**IN THE ENVIRONMENT COURT
AT AUCKLAND**

Decision [2026] NZEnvC 008

CONSENT ORDER

Proposed Plan Change 14 to the Waipā District Plan

Appendix S20 – Bardowie Industrial Precinct Structure Plan and Urban Design and Landscape Guidelines

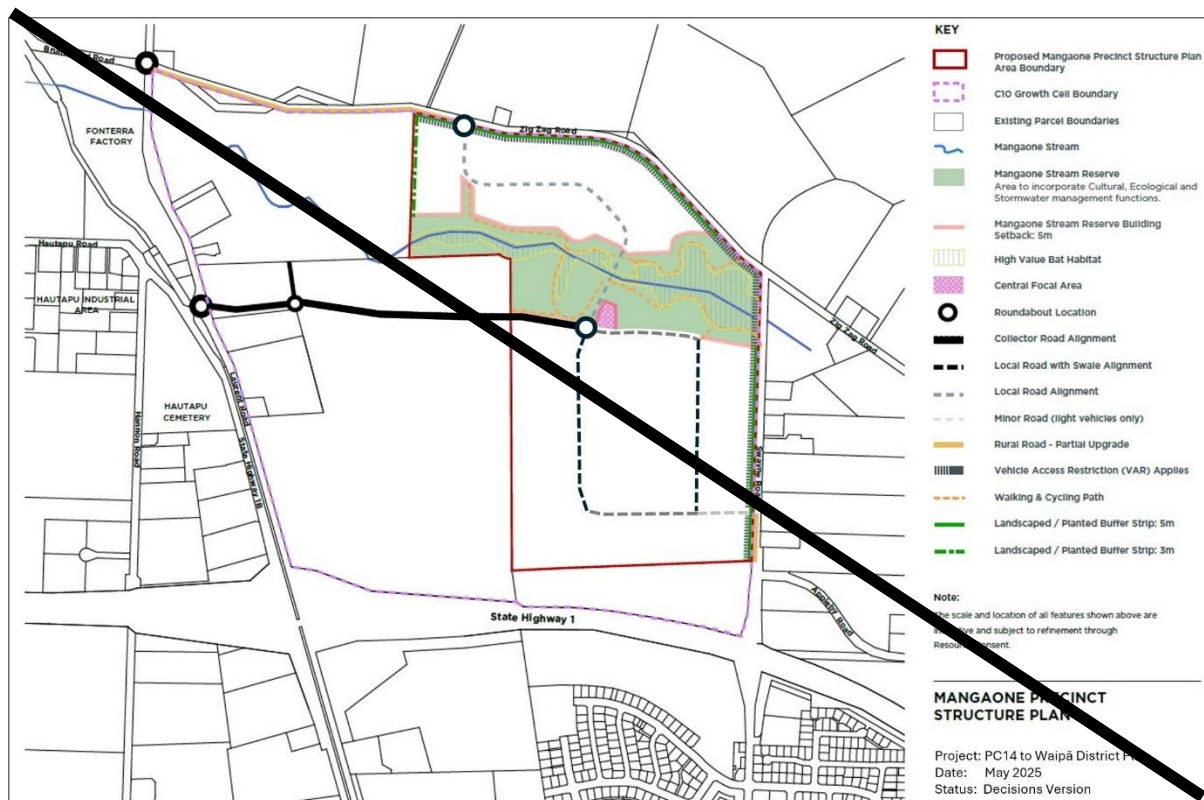
Replace and amend structure plan diagram as follows:

- Intersection between the east-west collector and the Henmar Trust land shall be a t-intersection rather than a roundabout; and
- The intersection in (a) above shall be identified on the structure plan as the “mid-block” intersection for the purpose of Rule 15.4.2.91B.

Figure S27A below is the Mangaone Precinct Structure Plan

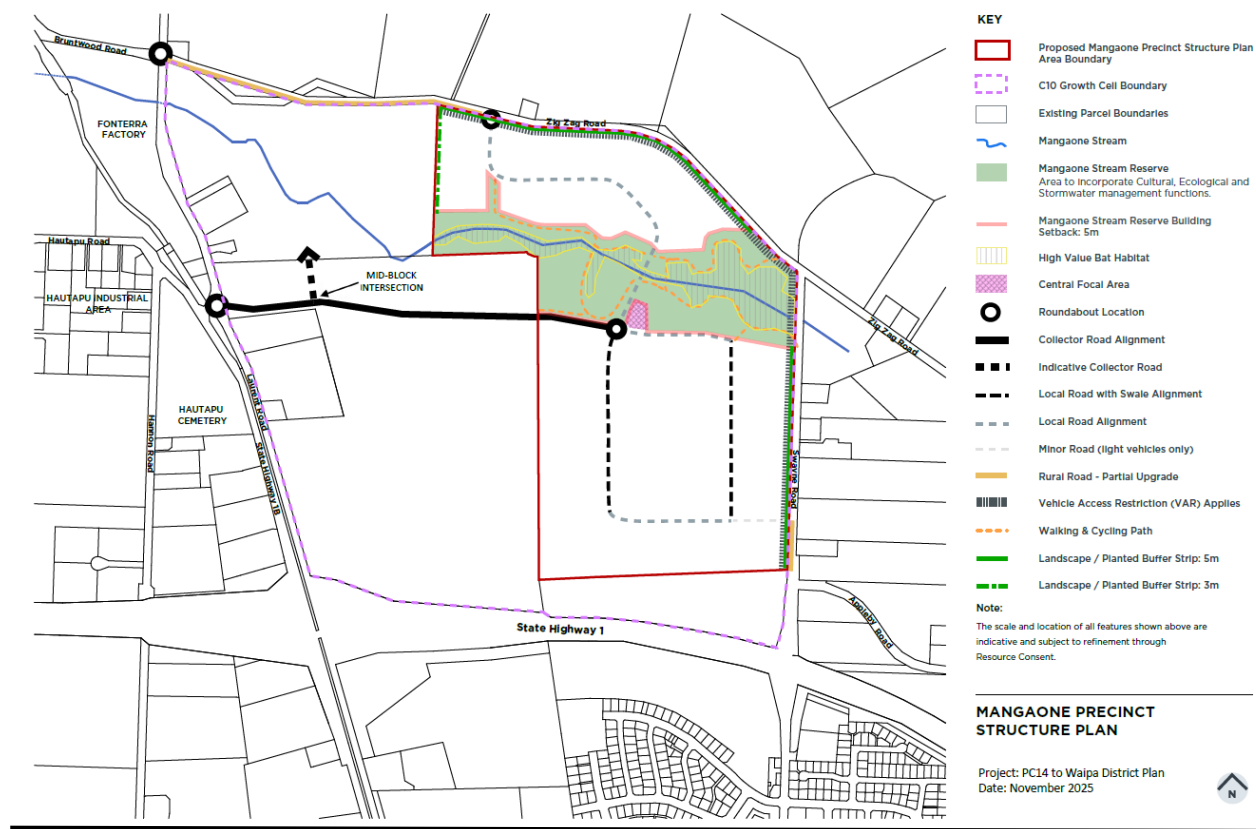
Replace and amend structure plan diagram as follows:

- Intersection between the east-west collector and the Henmar Trust land shall be a t-intersection rather than a roundabout;
- The intersection in (a) above shall be identified on the structure plan as the “mid-block” intersection for the purpose of Rule 15.4.2.91B; and
- The collector road extending north from the east-west collector shall be a dashed line rather than a solid line.
